## ATTACHMENT B – NRPP Report DA25/0011

Pre - lodgement Summary and DA Assessment Comments:

#### *Flooding comments*

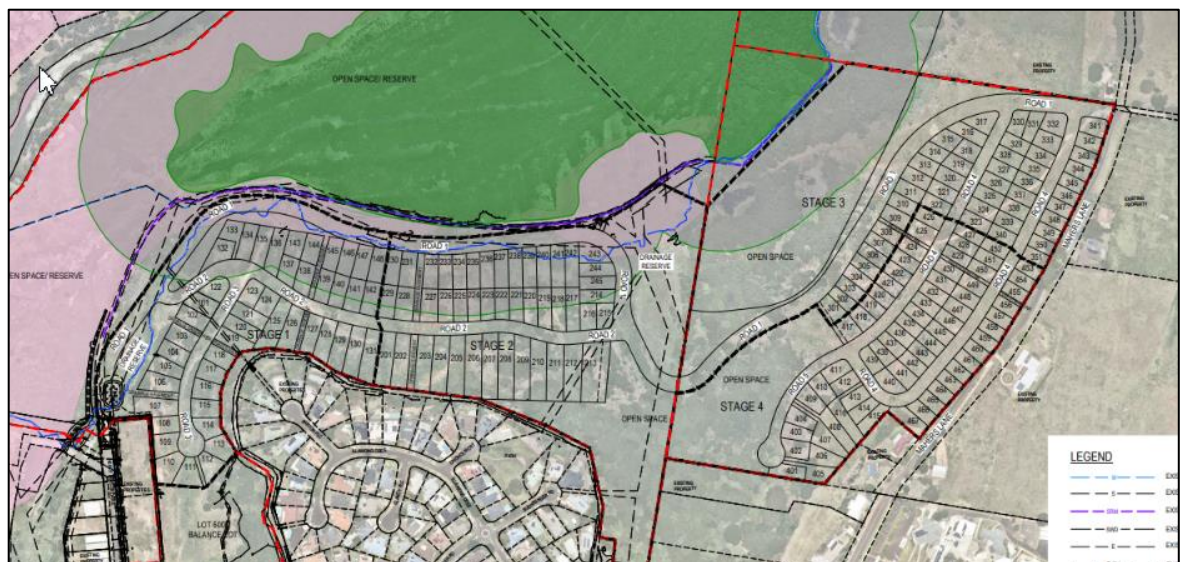
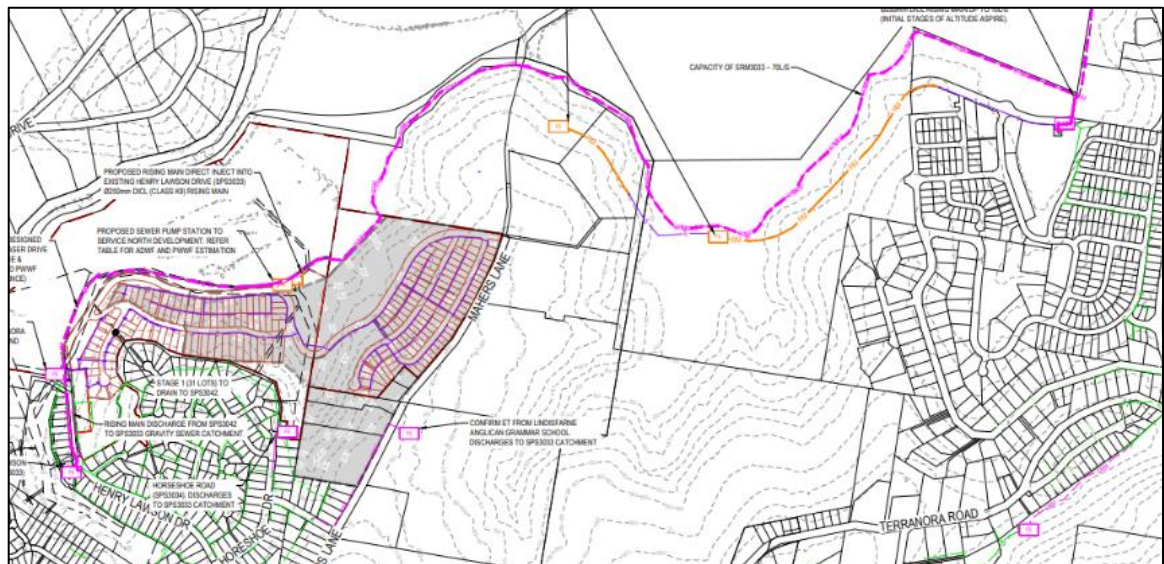
- Climate change design flood levels and Climate change flood planning levels are applicable to the subdivision being a greenfield site:
  - Climate change design flood level – 2.9m AHD
  - Climate change planning flood level – 3.4m AHD
  - Probable Maximum Flood – 5.7m AHD
- Majority of subdivision is located above the PMF, therefore evacuation provisions of Development Control Plan A3 are addressed.

**DA Assessment Comment:** Subject to the above comments in relation to stormwater, the proposed subdivision achieves compliance with flood related development standards and controls in terms of flood immunity and safe evacuation to ensure risk to life and property associated with the use of land is minimised. However, the ecological impact of such is not sufficiently addressed in the application as required under Clause 5.21(2)(e) of TLEP2014. As the consent authority must be satisfied of this matter and as the development fails to sufficiently address this matter for consideration, development consent must not be granted under Clause 5.21(2)(e).
